Randwick Local Planning Panel (Public) Meeting

Development Application Report No. D28/23

Subject: 3 Berwick Street, Coogee (DA/432/2022)

Proposal: Demolition of existing structures, Torrens title subdivision and the construction of two semidetached dwellings and associated site works.

Extract from the height plane diagram prepared by Environa Studio (Drawing 970)

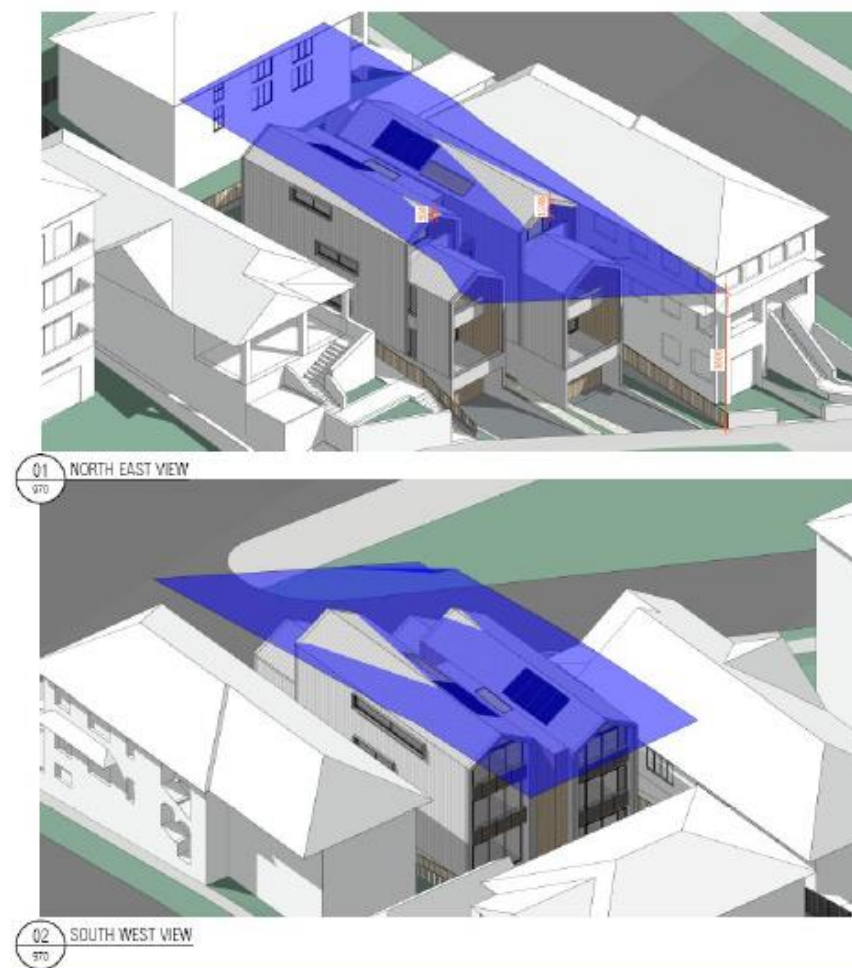
A small part of the northern end of the roof over Level 4 for both houses exceeds the 9.5 metre height limit as shown on the height plane diagram (refer to Figure 3) and the sections prepared by Envirova Studio. The maximum extent of the exceedance for House 1 is 1.246 metres (a 13.12% variation) and the maximum extent of the exceedance is 304mm for House 2 (a 3.2% variation).
